Access Compliance Report

Public Rights-of-Way

Intersection ID: 9616	Main Street: BRIARWOOD_DR	Cross Street: THE_PLAZA	Location: NE
ADA ID: 8F5994D213E3	Ramp Type: Perpendicular	Initial Pass/Fail: Fail	Overall Compliance: No
		Severity Score: 12.5

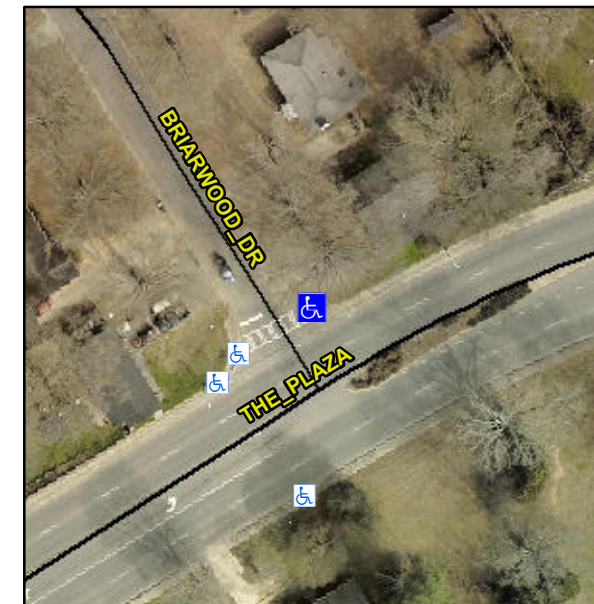
Not Found, R304.2.2

Compliance	Description	Data	Compliance	Description	Data
N/A	Ramp Length (in)	60.0	No	Ramp Slope (%)	8.4
Yes	Ramp Width (in)	48.0	Yes	Ramp XSlope (%)	0.3
N/A	Flare Type LT	N/A	N/A	Flare Type RT	N/A
N/A	Flare Slope LT (%)	N/A	N/A	Flare Slope RT (%)	N/A
N/A	Flare Traversable LT?	N/A	N/A	Flare Traversable RT?	N/A
N/A	Landing Length (in)	N/A	N/A	DWS Provided?	N/A
N/A	Landing Width (in)	N/A	N/A	DWS Contrast?	N/A
N/A	Landing Slope (%)	N/A	N/A	DWS Length (in)	N/A
N/A	Landing X Slope (%)	N/A	N/A	DWS Full Width?	N/A
N/A	Landing Curb? (Y/N)	N/A	N/A	DWS Offset (in)	N/A
N/A	Shared Landing?	N/A			
N/A	Gutter Ponding?	Yes	N/A	Gutter Slope (%)	N/A
N/A	Gutter Lip Ht (in)	N/A	N/A	Gutter X Slope (%)	N/A
N/A	Painted X Walk1?	Yes	N/A	Painted X Walk2?	N/A
	X Walk 1 Direction	To SW		X Walk 2 Direction	N/A
N/A	X Walk 1 Width (in)	88.0	N/A	X Walk 2 Width (in)	N/A
	X Walk 1 Slope (%)	3.4		X Walk 2 Slope (%)	N/A
	X Walk 1 X Slope (%)	0.2		X Walk 2 X Slope (%)	N/A

Remove & Replace Entire Ramp.
